91-19

## A. ANODE MATERIAL CHANGE

Alpha One/Alpha One Generation II and Bravo One and Two drives.

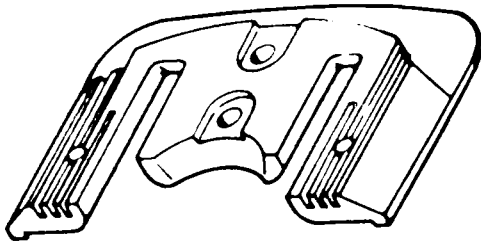
The material in the anodes is changed from ZINC to ALUMINUM ALLOY to provide increased corrosion protection in fresh and salt water. These anode assemblies will supersede all zinc anodes being used today, on Alpha One/Alpha One Generation II and Bravo drive units. The anode trim tab will supersede at a later date.

815933A1 will supersede to 821629A1

817373A1 will supersede to 821630A1

43994A2 will supersede to 821631A1
